2004-11-04 IEEE C802.16e-04/469

## Ambiguity in PHY layer §8.3 OFDM frequency and timing requirements

Juergen Otterbach / Joerg Schaepperle / Roland Muenzner / Torsten Fahldieck Alcatel SEL AG

Figure 1: Possible differences in OFDM symbol duration

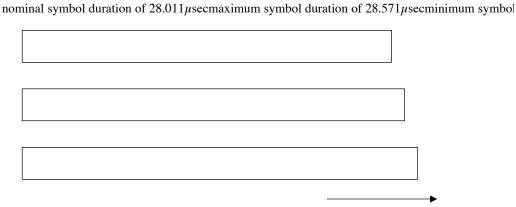
According to this tolerance the SS is allowed to transmit OFDM symbols with differences in duration as shown in Figure 1 with a Cyclic Prefix (CP) time of 1/4 of the "useful" symbol time assumed. The symbol time extension by the CP is 256/4 = 64 samples. The whole symbol is equivalent to 320 samples that correspond to symbol time  $T_s = 28.011\mu$ sec nominal.

In a view of the Base Station receiver a nominal symbol duration of  $28.011\mu$ sec is expected. An UL OFDM symbol with maximum symbol duration of  $28.571\mu$ sec is 6.4 samples longer than the expected nominal symbol duration of  $28.011\mu$ sec. A detection of the short preamble using time domain correlator principles would fail.

The above ambiguity could be solved by explicitly stating that the accuracy of the symbol clock frequency at the SS is guaranteed by its locking to center frequency at the SS, thereby exploiting the fact that through the requirement, that the symbol clock frequency and the center frequency are derived from a single reference at the BS, they have a fixed and predefined ratio.

At the SS, both the transmitted center frequency and the symbol clock frequency shall be synchronized and locked to the BS with a tolerance of maximum 2% of the subcarrier spacing. Additionally the symbol clock frequency at the SS shall be locked to the center frequency at the SS which guarantees a tolerance for the symbol clock frequency at the SS of maximum 2% of the subcarrier spacing divided by the center frequency.
